Technical Note

Project:	Campbeltown Flood Protection Scheme & Surface Water Management Plan		
Project No:	60541587		
Subject:	Additional Design Information on Meadows SuDS Proposals		
Prepared by:	Aisling McGilloway	Date:	24/06/19
Checked by:	George Harley	Date:	25/06/19
Approved by:	Dylan Huws	Date:	05/07/19
Issue Record:	Rev0

Figure 2-1 Updated basin position

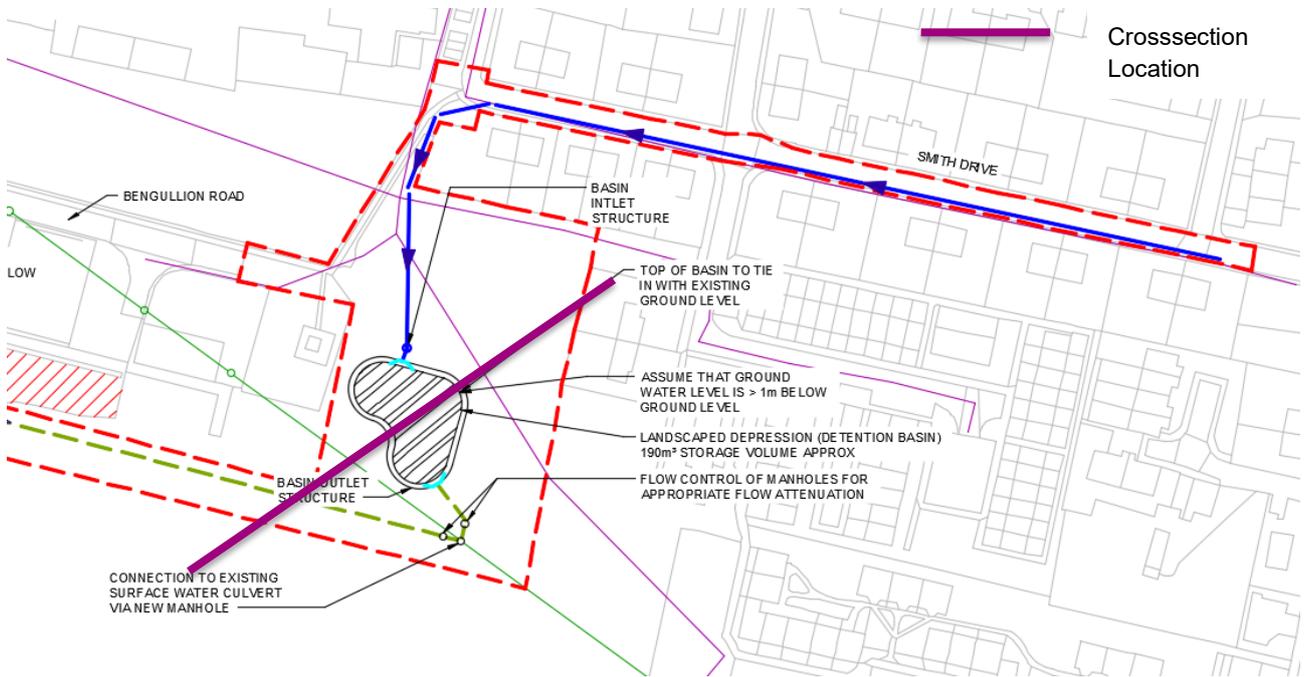
During the optioneering phase the basin in question was sited in the lower area highlighted in the objection. However a Scottish Water sewer pipe serving Meadowpark was identified and in order to avoid a clash between the basin's outlet and this sewer the basin was moved to an area where sewer pipe was deeper. Following further assessment of levels, it is possible to move this basin and still achieve suitable pipe gradients for the proposal to work hydraulically. Based on the concerns raised regarding privacy, the basin may moved further into the Meadows (**Figure 2-1**). The conveyance of storm water to the basin will be via an underground system therefore for the design to work hydraulically underground pipes will need to tie into the basin. On this basis, the basin will be excavated below current ground level. It is proposed to landscape the top of basin level

Figure 2-2 Section through repositioned detention basin

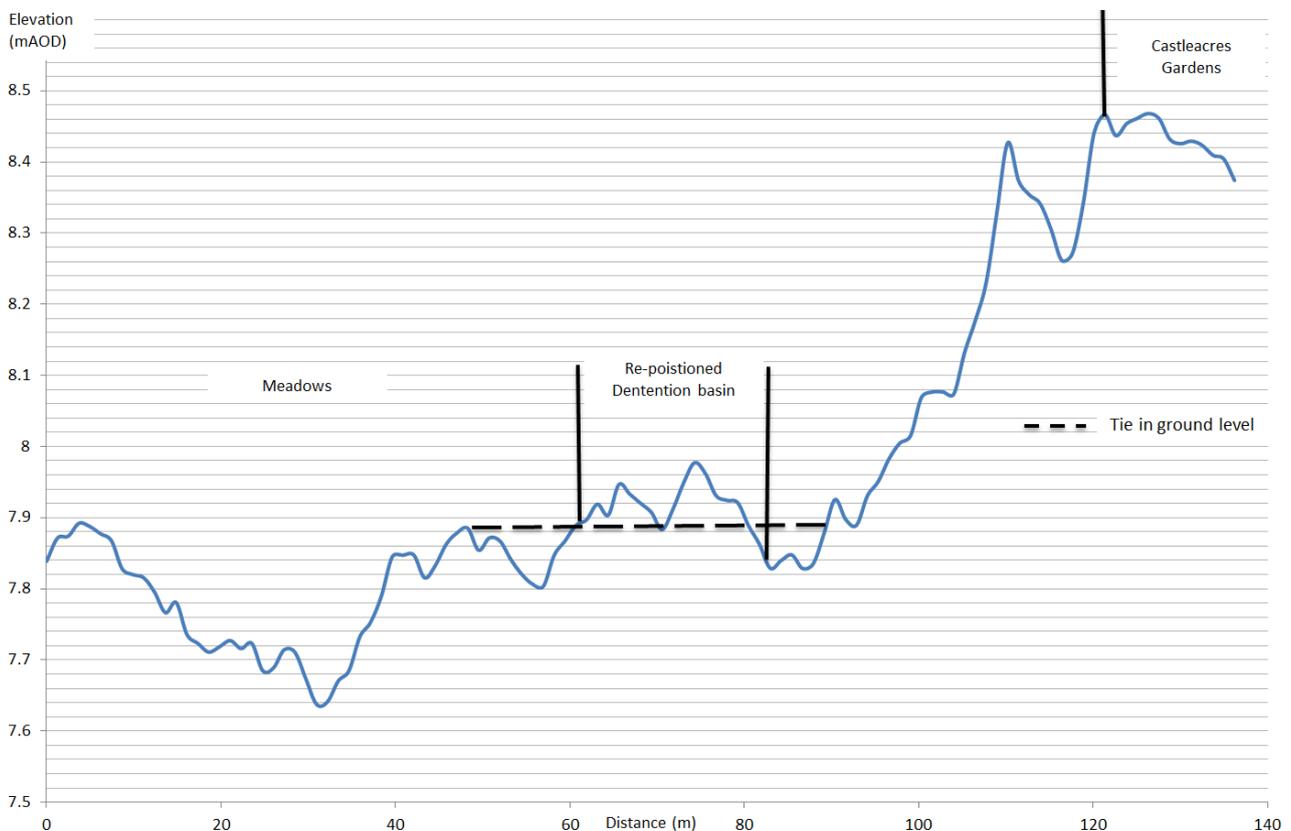
into existing ground levels as shown in **Figure 2-2** below where no significant raising of levels will be required. It should be noted that as with any construction project the final details of the basin may need to be modified during the detail design process in response to more detailed information on site conditions. However, significant bunding around the depression is not anticipated.

This section also demonstrates that any overtopping of the basin in an event greater than an extreme 1 in 200 year plus climate change event would flow overland away from properties to lower lying land at The Meadows area, where there will be little negative impact. This is based on existing ground data which shows properties sit approximately 0.5m above the proposed basin. Topographic survey is planned to understand

Figure 2-4 Exceedance flow path from basin

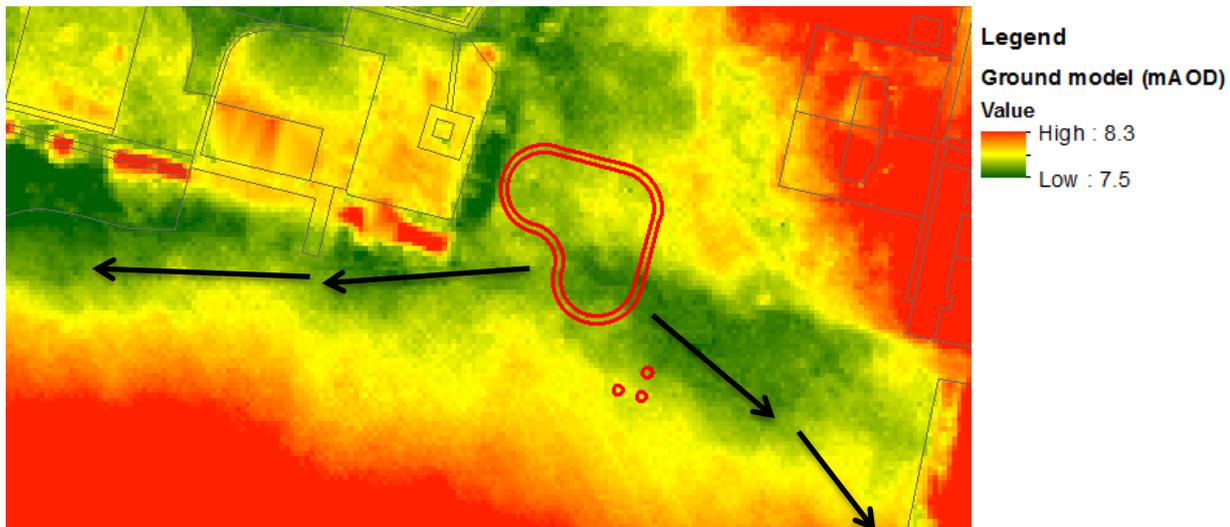
levels in more detail in order to carry out detail design of the scheme. Where necessary this overland flow path will be reinforced with subtle landscaping to grade levels towards the Meadows, away from property in an exceedance event. These overland flow paths are illustrated in **Figure 2-3** below.
